Ebrahim Textile Mills

Structural Safety Inspection Report

Observations & Actions

Pakistan Accord Initial Safety Inspection Report

Figure 2.6 - Building 01- Location of columns cracking in overhead water tank and warehouse

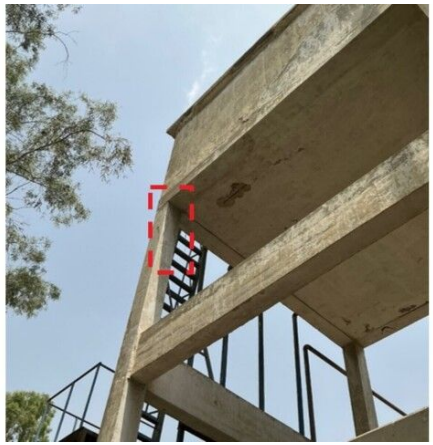
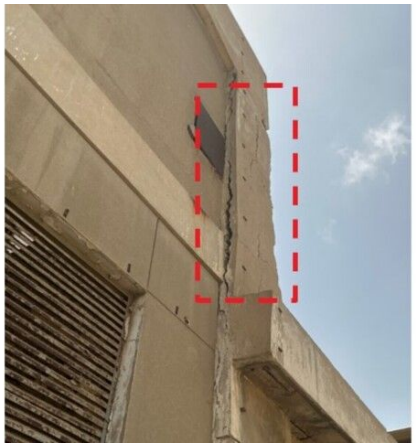
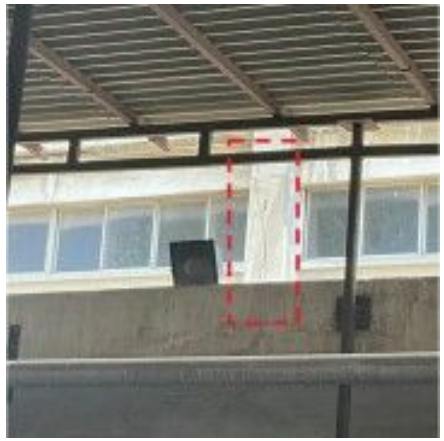
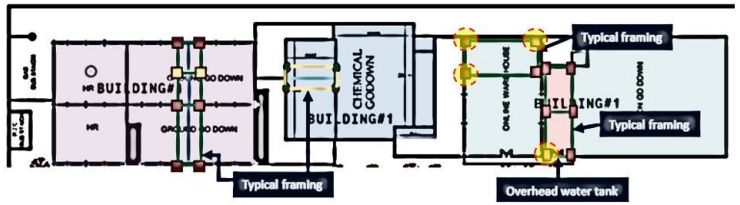
This refers to Building 1 where cracking in multiple columns was observed at multiple locations and levels. The column was found to have cracks penetrating through the concrete, potential cause for damage is due to the water ingress which causes corrosion of reinforcement present in the column resulting expansion in steel bar which is damaging concrete at multiple levels. Although columns are not overstressed, corrosion can compromise the integrity and safety of structure. F-202506-017631

Timeline	Remediation Plan
Medium Term FIN-0022566	Structural engineer to carry out a detailed assessment of the column to identify the cause of the cracking and the residual load capacity including condition of concrete and rebar. Structural Engineer to investigate whether such cracks exist in any other columns, particularly at Ground floor level. Propose measures to prevent future damage and to repair the existing damage / strengthen the column as required and submit to Pakistan Accord for approval.
Longer Term FIN-0022567	Carry out the remedial works.

Figure 2.11 - Building B6 (Structure 1)- Location of spalling in roof slab

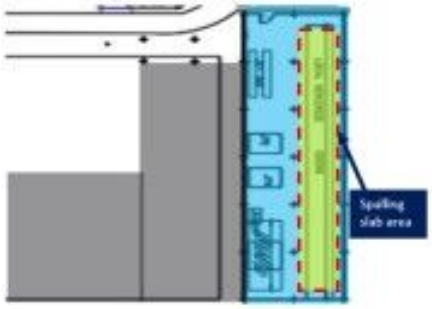
This refers to the roof floor slab of Building B6 (Structure 1), the concrete of roof slab was spalling. The potential cause of the spalling might be the steam coming out from the mercerize and dryer machines. F-202506-017637

Timeline	Remediation Plan
Medium Term FIN-0022572	Identify the cause of the damage and propose measures to prevent further water damage Inspect damage to the slab and propose repairs to structure Submit report capturing above to Pakistan Accord for approval
Longer Term FIN-0022573	Implement remedial works Continue to monitor for future signs of water ingress/damage

Figure 2.16 - Building 5 (Structure 1)- Spalling in the shell slab of the building

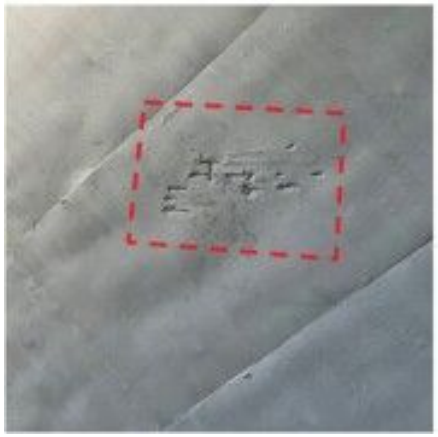
This refers to the roof floor slab of Building B5 (Structure 1 and 3), the concrete of roof slab was spalling. The potential cause of the spalling for structure 5 might be the steam coming out from the mercerize and bleaching machines and for structure 3 is the lack of waterproofing of the shell slab. F-202506-017638

Timeline	Remediation Plan
Medium Term FIN-0022574	Identify the cause of the damage / source of water ingress and propose measures to prevent further water damage Inspect damage to the slab and propose repairs to structure Submit report capturing above to Pakistan Accord for approval
Longer Term FIN-0022575	Implement remedial works Continue to monitor for future signs of water ingress/damage

Figure 2.19 - Building 5 (Structure 4) - Signs of impact damage in column at roof

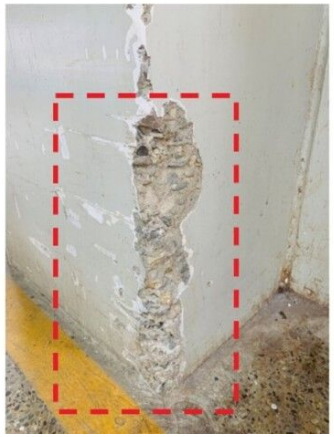
This observation relates to the multiple columns at roof of Building 5 (Structure 4), which was found to be damaged due to impact of trollies at the roof level. F-202506-017639

Timeline	Remediation Plan
Medium Term FIN-0022576	Repair damage to column corners and external faces
Longer Term FIN-0022577	Install protective measures to prevent damage recurring and submit the pictorial evidence to Pakistan Accord. Continue to monitor condition of columns in highly trafficked areas

Figure 2.25 - Building 6 (Structure 1) - Location of the damaged columns at ground floor

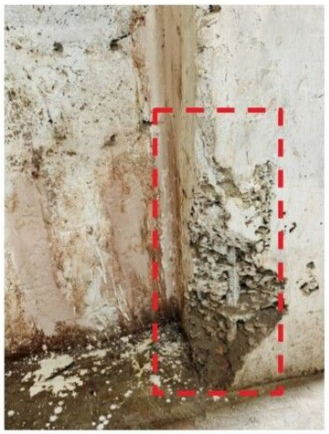
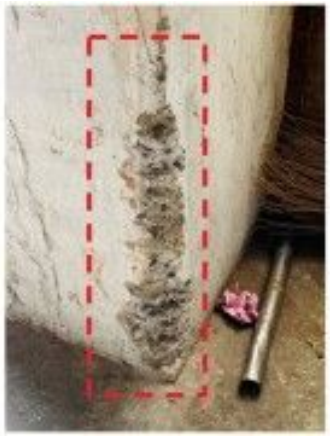
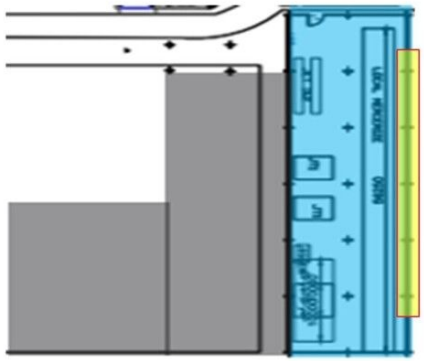
This observation relates to the multiple columns at roof of Building 6 (Structure 1), which was found to be damaged due to impact of trollies at the ground floor level. F-202506-017640

Timeline	Remediation Plan
Medium Term FIN-0022578	Repair damage to column corners and external faces
Longer Term FIN-0022579	Install protective measures to prevent damage recurring and submit the pictorial evidence to Pakistan Accord. Continue to monitor condition of columns in highly trafficked areas
